RE: St Luke's East Hospital MRI REPLACEMENT
Permit No: PRCOM20202038
80 NE Saint Luke's Blvd,
Lee's Summit, MO 64086

The following is our response to your review of the referenced project dated July 29, 2020

Building Plan Review

A2 FLOOR PLAN 1/4" = 1'-0"

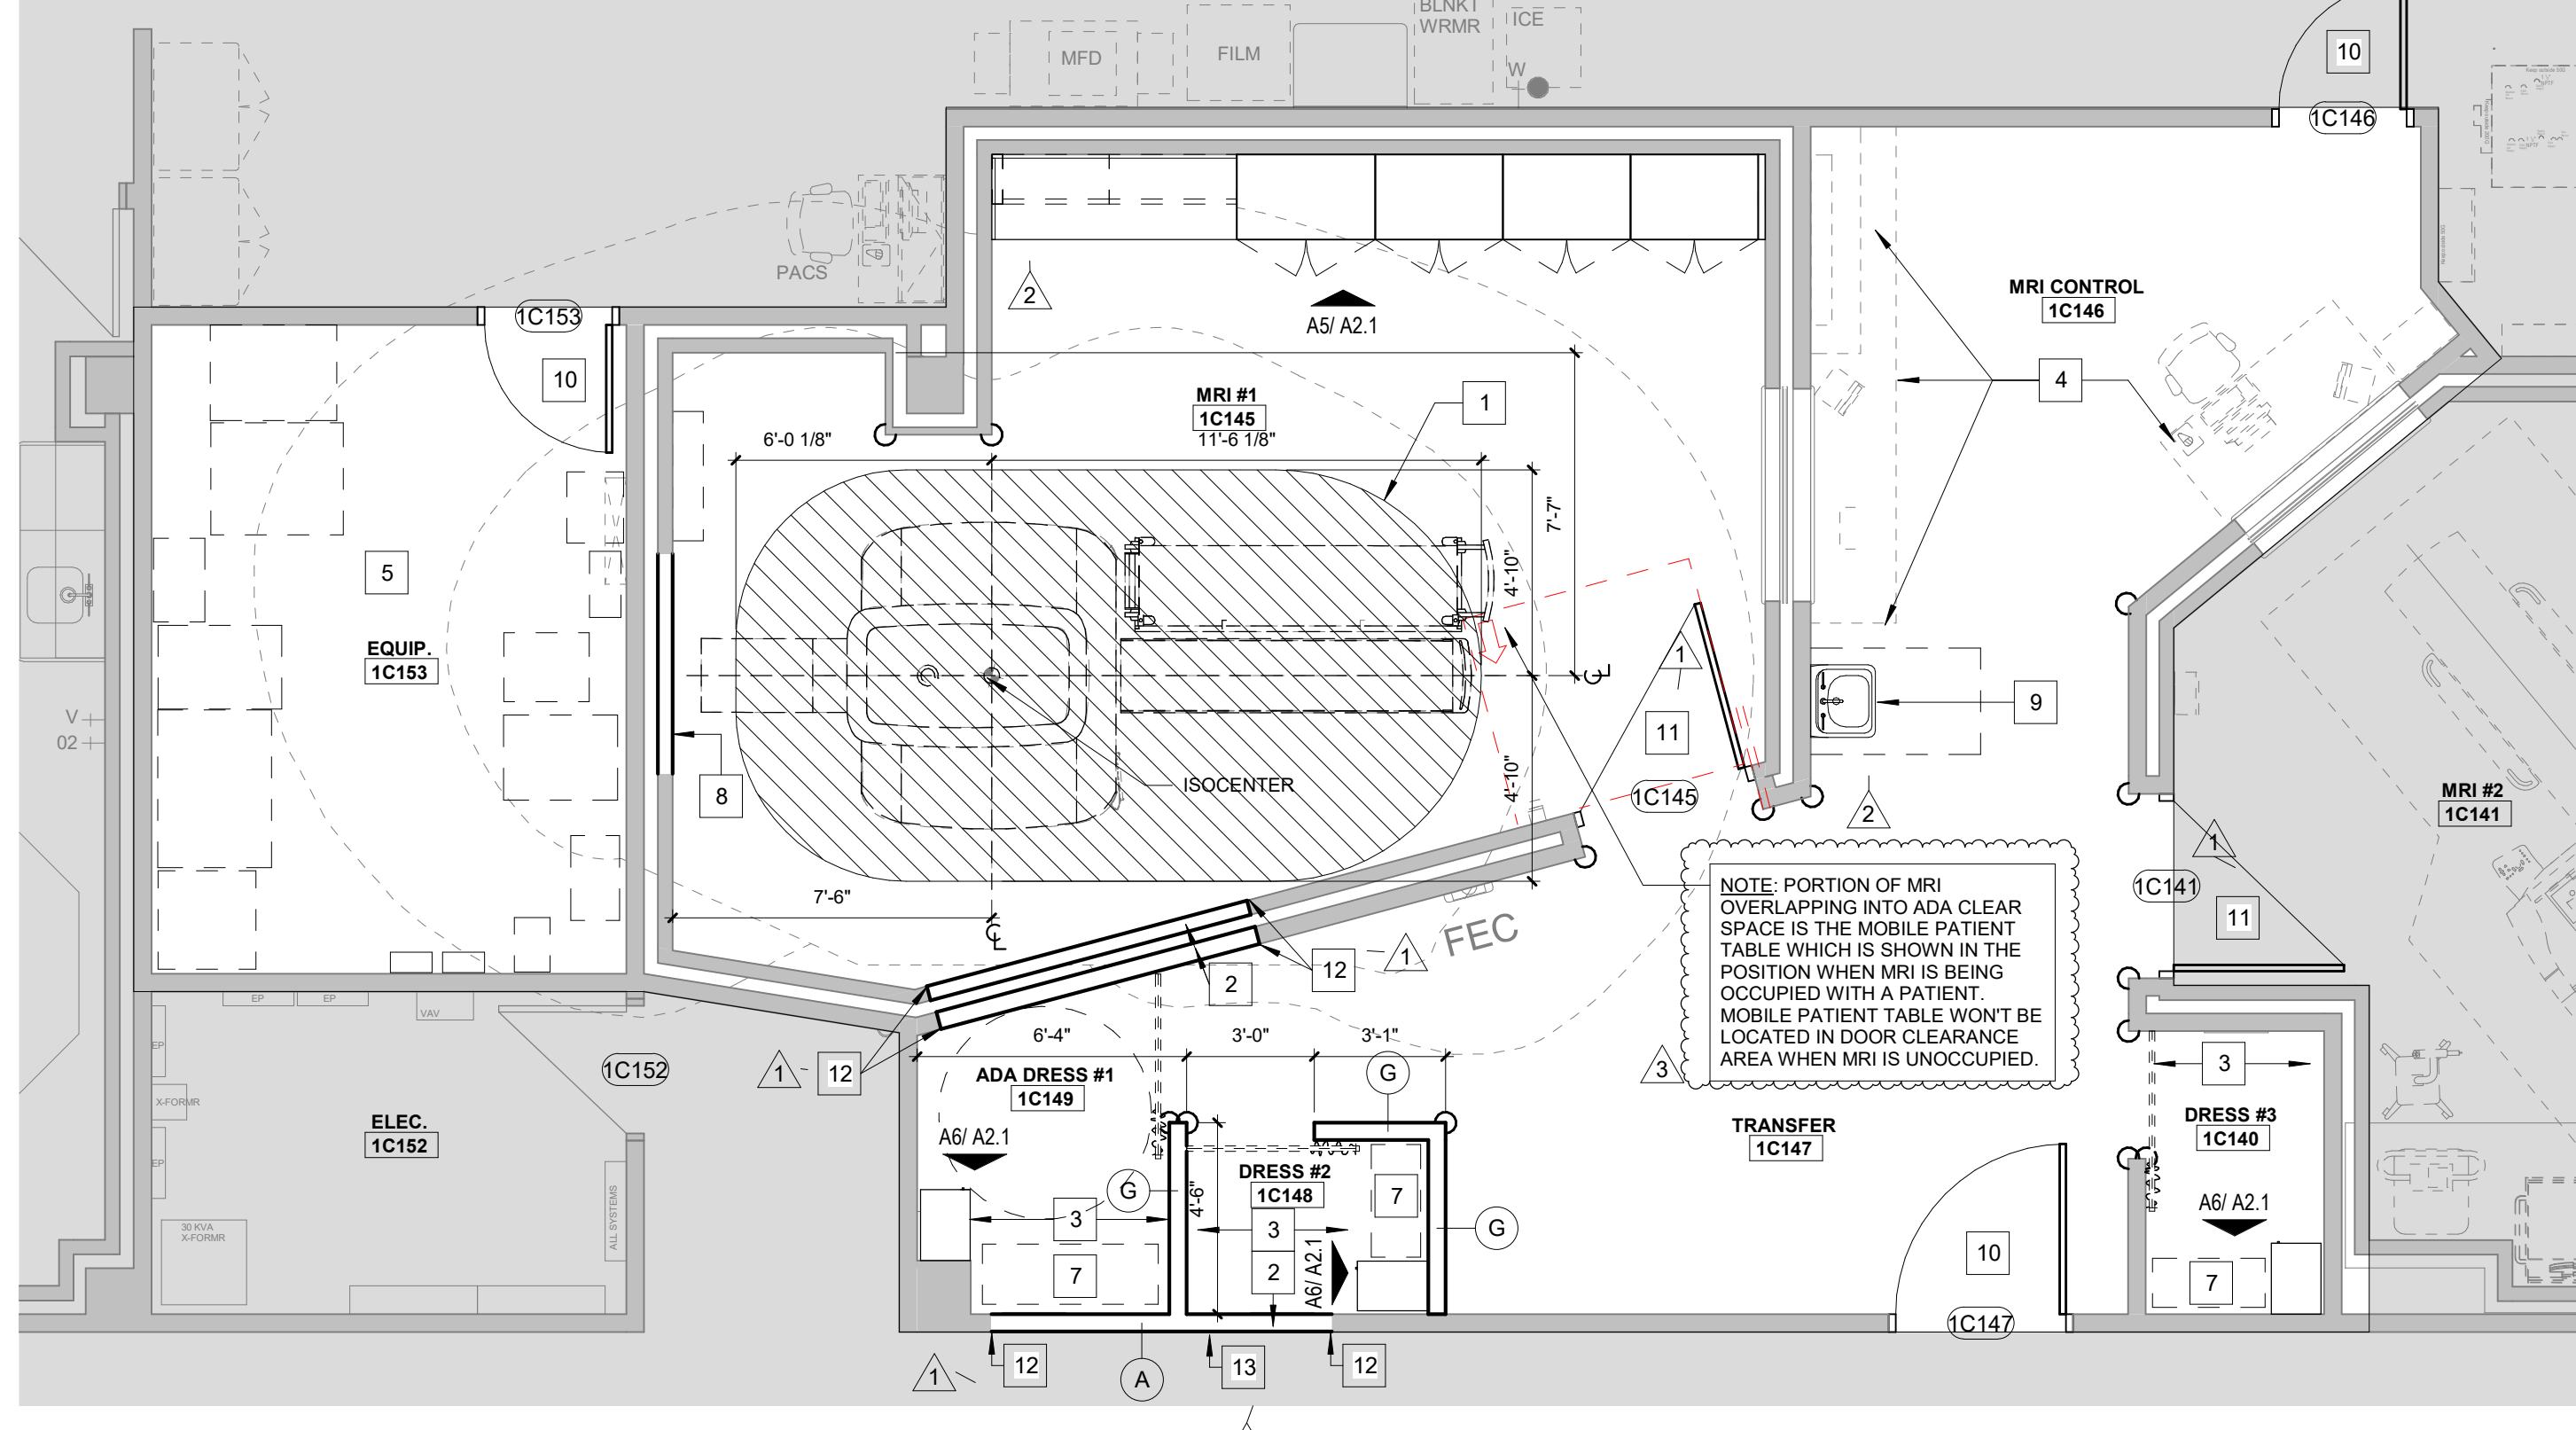
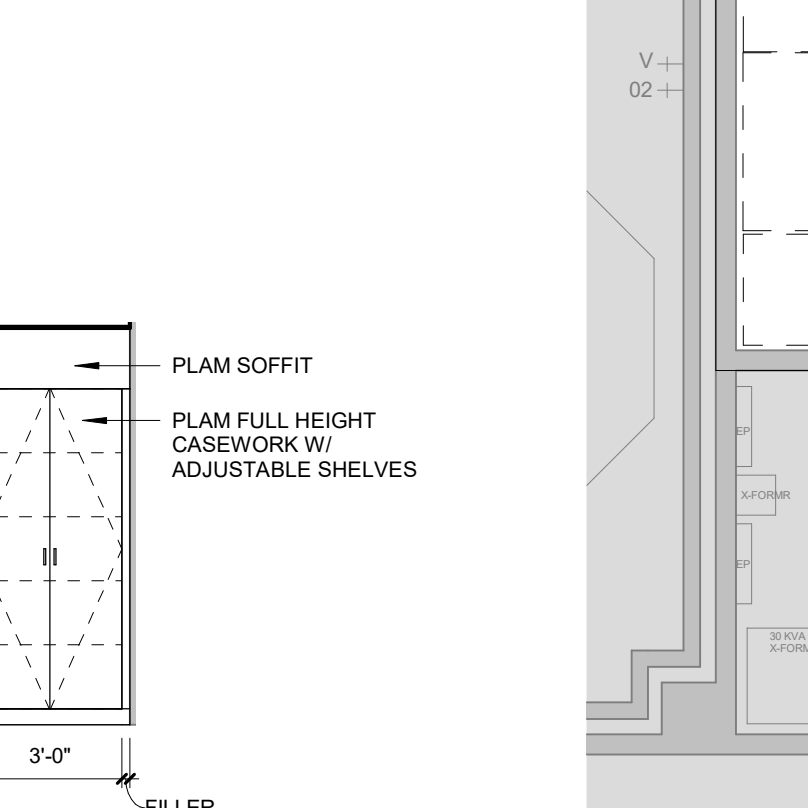
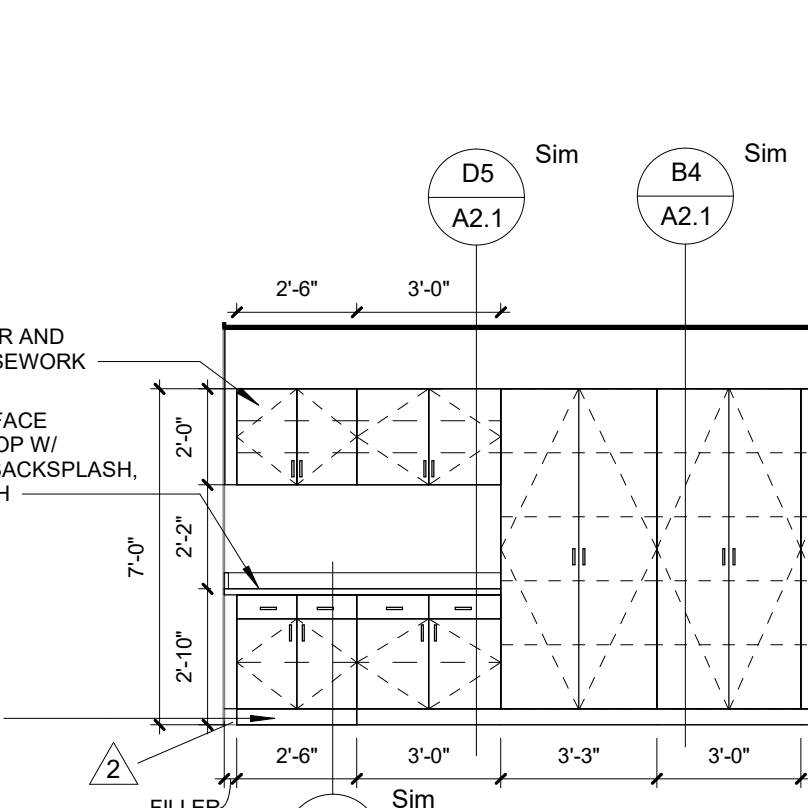
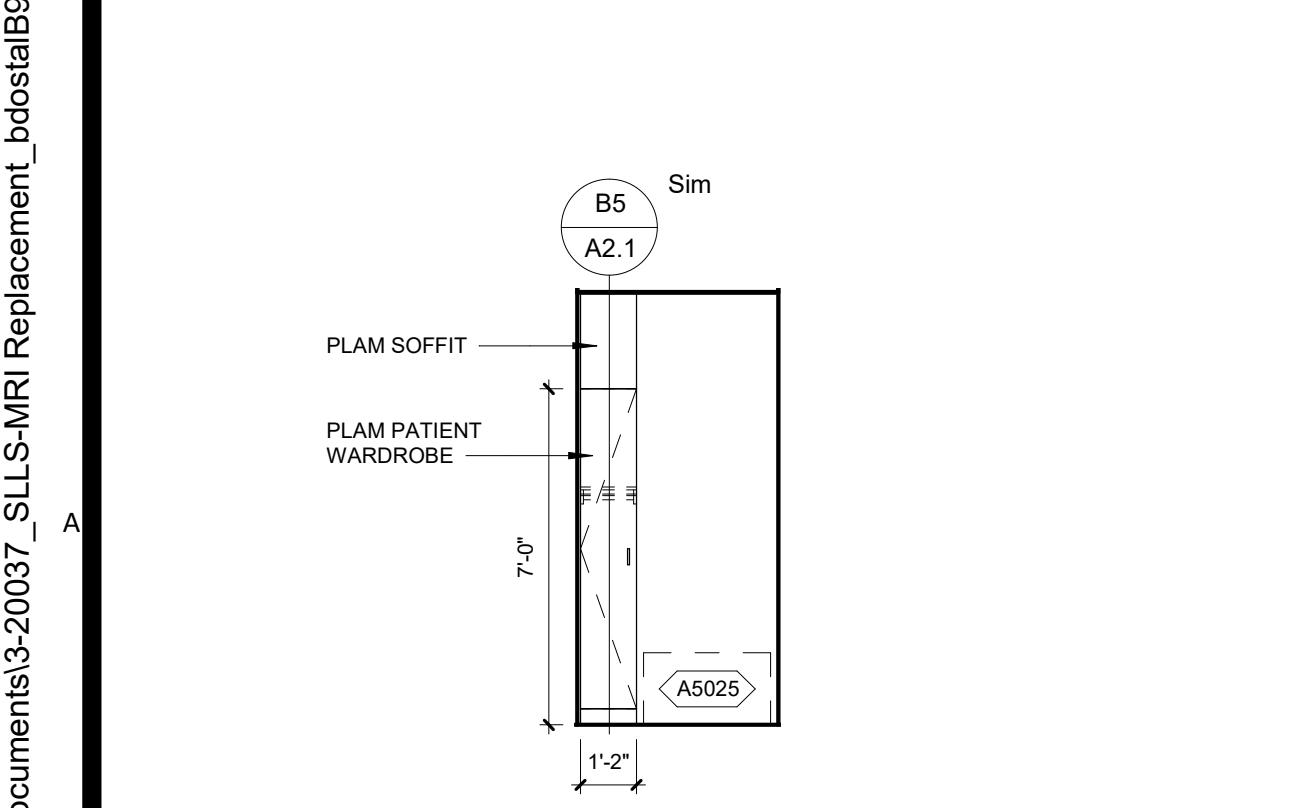
Action required: Provide minimum door maneuvering clearance at MRI side of door 1C145

Response: *The item that is being reference that's within the 5' ADA clearance is the "FlexTrak" (FT) mobile patient table. It is only shown there as that's the position it is in when the patient is transferred from it to the MRI table. Basically, it's a "MRI gurney" and will be moved away from the MRI when not needed. Additional note to clarify MRI layout added to sheet A2.1. Door clearance shown on A2.1.*
